QUALITY ASSURANCE -- NON-CONFORMANCE REPORT

Report No: NCR-000879

Component: Bikepath Assembly BK004A-056

Reference Description: Steel backing was not properly placed and held in Bikepath Assembly (BK004A-056)

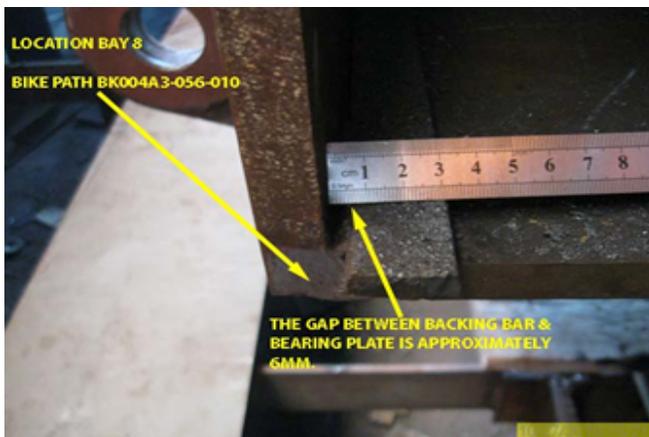
During the Caltrans Quality Assurance (QA) in-process observations of the fabrication of OBG Bike path plate BK004A3-056-010, this QA Inspector discovered the following issue:

- Steel backing was not properly placed and held in intimate contact with the base metal.
- The gap between steel backing and bearing stiffener plate is observed approximately 6mm.
- The weld is Complete Joint Penetration (CJP) with steel backing joining the Bearing Plate and End Plate (side plate) of bike path.
- The weld was already completed.
- The weld is identified as: BK004A3-056-010.
- The member is located in bay # 8.

-AWS D1.5 2002, Section 3.13.5: "Steel backing shall be placed and held in intimate contact with the base metal. The maximum gap between steel backing and the base metal at the weld root shall be 2 mm."

-AWS D1.5 2002, Section 3.13.2: "Groove welds made with the use of steel backing shall have the weld metal thoroughly fused with the backing. Steel backing shall be continuous for the full length of each weld made with backing."

Reference Resolution: ZPMC has removed the backing bar not in contact with the weld and performed NDT of the weld area where the backing bar was removed and found it acceptable.

ZPMC has removed the backing bar not in contact with the weld and performed NDT of the weld area where the backing bar was removed and found it acceptable. ABFJV has instructed all inspectors to pay more attention during joint fit up to ensure that the backing bar is in contact and properly welded to the plates before accepting the joint fit up. Based on this ZPMC requests closure of this NCR.

The proposed resolution is acceptable. This NCR is considered closed.

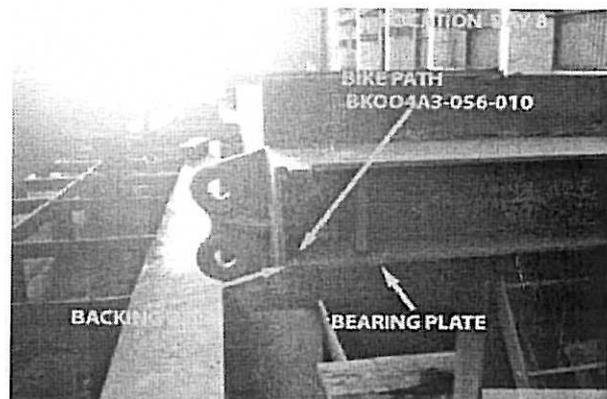
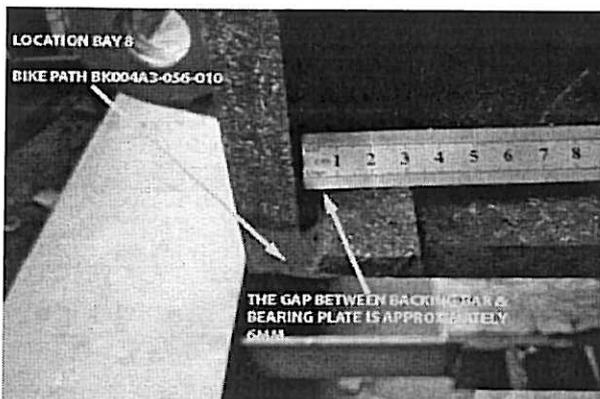
During the Caltrans Quality Assurance (QA) in-process observations of the fabrication of OBG Bike path plate BK004A3-056-010, this QA Inspector discovered the following issue:

- Steel backing was not properly placed and held in intimate contact with the base metal.
- The gap between steel backing and bearing stiffener plate is observed approximately 6mm.
- The weld is Complete Joint Penetration (CJP) with steel backing joining the Bearing Plate and End Plate (side plate) of bike path.
- The weld was already completed.
- The weld is identified as: BK004A3-056-010.
- The member is located in bay # 8.

-AWS D1.5 2002, Section 3.13.5: "Steel backing shall be placed and held in intimate contact with the base metal. The maximum gap between steel backing and the base metal at the weld root shall be 2 mm."

-AWS D1.5 2002, Section 3.13.2: "Groove welds made with the use of steel backing shall have the weld metal thoroughly fused with the backing. Steel backing shall be continuous for the full length of each weld made with backing."

ZPMC to remove the defective backing bar and to perform NDT to confirm the weld in question is not affected. ABF's and ZPMC's QC inspectors have been reminded to pay special attention to the backing bars during joint fit-up inspections.

The defective backing bar has been removed and NDT done on the affected weld. Result was found acceptable. QC inspectors were instructed to pay special attention to joint fit-up to ensure the backing bars are intact.
